Access Compliance Report

Public Rights-of-Way

(Curb Ramps)

Intersection ID: 31813	Main Street: WENDOVER_HILL_CT	Cross Street: CHURCHILL_RD	Location: NW
ADA ID: 72D3F779B386	Ramp Type: BlendTrans1	Initial Pass/Fail: Fail	Overall Compliance: No
Severity Score: 33.75			
Codes/Mitigation Info/Possible Solution		Field Measurements/Component Compliance

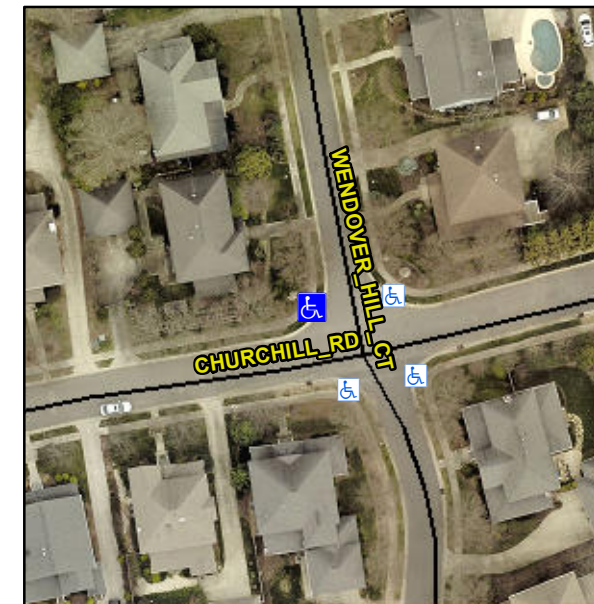
Not Found, R304.5.1, R304.5.3

Compliance	Description	Data	Compliance	Description	Data
N/A	Ramp Length (in)	48.0	Yes	BlendTrans Slope (%)	3.7
No	Ramp Width (in)	44.0	No	BlendTrans XSlope (%)	7.2
N/A	Flare Type LT	N/A	N/A	Flare Type RT	N/A
N/A	Flare Slope LT (%)	N/A	N/A	Flare Slope RT (%)	N/A
N/A	Flare Traversable LT?	N/A	N/A	Flare Traversable RT?	N/A
N/A	Landing Length (in)	N/A	N/A	DWS Provided?	N/A
N/A	Landing Width (in)	N/A	N/A	DWS Contrast?	N/A
N/A	Landing Slope (%)	N/A	N/A	DWS Length (in)	N/A
N/A	Landing X Slope (%)	N/A	N/A	DWS Full Width?	N/A
N/A	Landing Curb? (Y/N)	N/A	N/A	DWS Offset (in)	N/A
N/A	Shared Landing?	N/A			
N/A	Gutter Ponding?	N/A	N/A	Gutter Slope (%)	N/A
N/A	Gutter Lip Ht (in)	N/A	N/A	Gutter X Slope (%)	N/A
N/A	Painted X Walk1?	No	N/A	Painted X Walk2?	No
	X Walk 1 Direction	To S		X Walk 2 Direction	To E
	X Walk 1 Width (in)	N/A		X Walk 2 Width (in)	N/A
	X Walk 1 Slope (%)	2.9		X Walk 2 Slope (%)	1.5
	X Walk 1 X Slope (%)	2.2		X Walk 2 X Slope (%)	4.3

N/A	Ramp inside XWalk1?	N/A	N/A	Ramp inside XWalk2?	N/A
	Road Slope (%)	5.5		Clear Space?	N/A
	Road X Slope (%)	4.4	N/A	Clear Space to XWalk (in)	N/A
N/A	Any Obstructions?	N/A	N/A	Storm Grate/Utility Hazard?	N/A
	Obstruction Type			Storm Grate/Utility Type	
		N/A			N/A
		Yes		Surface Condition? (G/P)	Good
		No		Curb Slope (%)	15.4

Remove & Replace Curb Ramp With Two New Directional Ramps or Equivalent.
